## MEMORANDUM

**To:** Alison Manugian, Dracut Community Development Director  
**From:** James Thorne, PE, Business Manager IV  
Sam Spelman, Scientist II  
**Date:** June 6, 2025  
**Project Name:** Dracut CC TO 2041 Bridge Street Peer Review  
**Project Number:** Green No. 24016.06XX  
**Subject:** Field Review of Wetland Delineation at 2041 Bridge Street, Dracut, MA

**Figure 1:** Recommended alteration to the BVW Series “A” in red (replacement of flags A202 and A203).

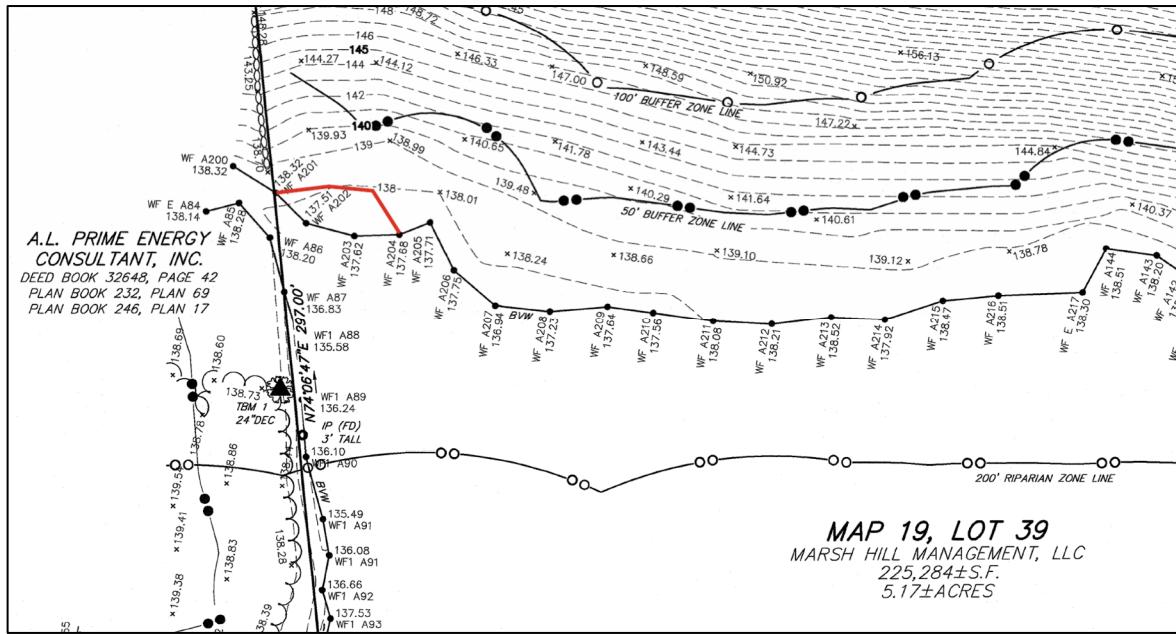
A forested area located eastward of wetland flags (WFs) #A202 and #A203 was identified as an upland area during Hancock Associates' assessment. However, the vegetation community in this area was dominated by a number of hydrophytic plant species, including sensitive fern (*Onoclea sensibilis*), cinnamon fern (*Osmunda cinnamomeum*), and royal fern (*Osmunda regalis*). This area also contained hydric soils (depleted matrix) and evidence of hydrology (soil saturation). The staff Wetland Scientist's recommendation is to omit the WF#s A202 and A203 and replace them with the alternative delineated boundary, which has been flagged in the field and labeled "GIA-WF-A202 and GIA-WF-A203". These new flags shift the BVW boundary approximately 15 feet east in the identified area. The Wetland Scientist's disagreement with the resource area delineation concludes at WF #A204, and they concur with the placement of the remainder of the "A" Series boundary. Moving these flags eastward will ensure that the aforementioned area is included as part of the BVW delineated by the Series "A".
